## VESA STANDARDS CHANGE REQUEST FORM

<b>TITLE:</b>	DSC 1.2b C model improvements and narrow slice warning SCR
<b>AFFECTED DOCUMENT:</b>	DSC 1.2b
<b>REVISION CATEGORY:</b>	Category 1
<b>SUBMITTED TO:</b>	Task Group
<b>SPONSOR:</b>	Fred Walls, Broadcom

## Summary of the Proposed Change(s)

### Native 422 mode RCB Overflow Cases

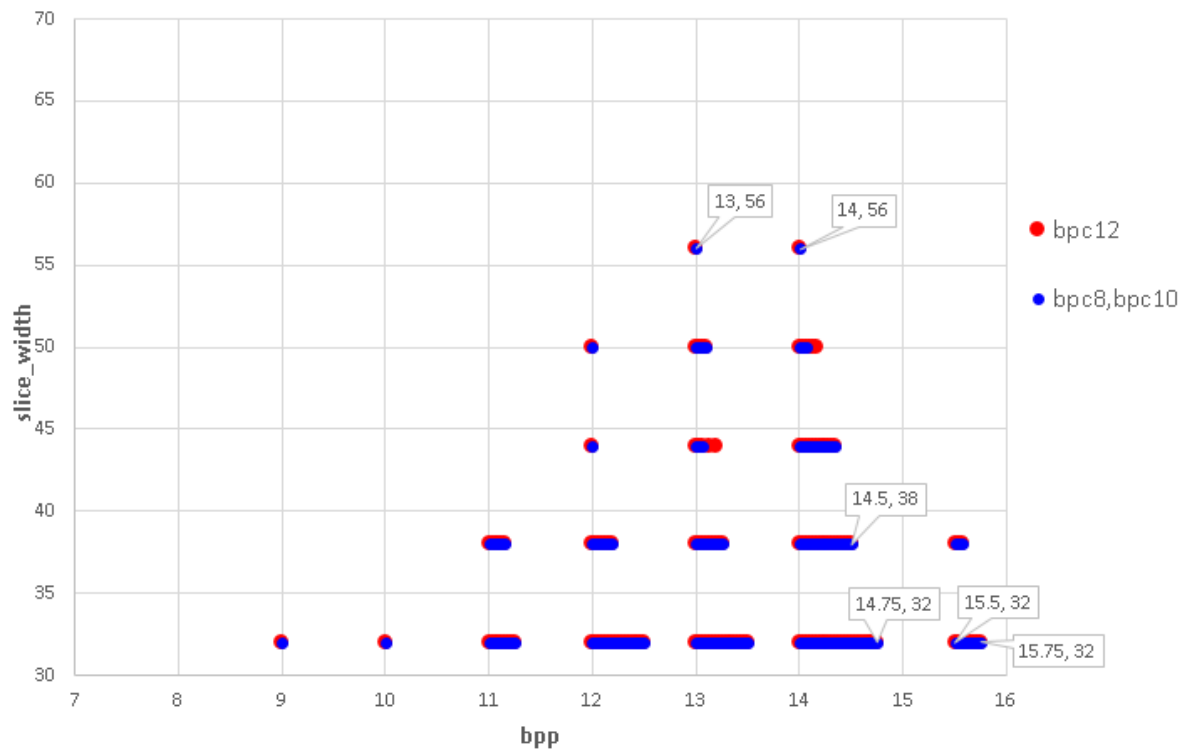
I fixed 8bpc and 10bpc input issue as you pointed out and reran them all, all the failure cases are listed in the xls, and plotted chart like below.

The results of 8 bpc and 10bpc are exactly same, results of 12bpc have 5 more overflow cases at slice\_width=44 and 50.

We are using DSC model to encode random images, we've found "RCB overflow" issue in some small slice\_width cases.

As an example, in native 422 mode, we traversed all the possible cases like below:

bpc= 8/10/12, bpp from 7.0 ~ 16.0 with step 1/16, slice\_width from 32 to 128 with step 2, slice\_height=CEIL( 15000/slice\_width).

- 1, is (or will) there any guideline about the slice\_width selection?
- 2, is (or will) there any guideline about RCB parameter adjustment in overflow cases?

Therefore, the warning code was changed to account for unbudgeted bits resulting from partial groups when performing the *rc\_range\_parameters[14].range\_max\_qp* check. This change does not affect any cases where the slice width is an integer multiple of 3 (or 6 if *native\_422* or *native\_420* is used). Many typical DSC use cases involve large slice widths and thus would not be impacted by this change.

In order to help users make appropriate adjustments easily, GENERATE\_RC\_PARAMETERS can now be configured to a value of 2 to automatically adjust the *rc\_range\_parameters[14].range\_max\_qp* parameter if needed.
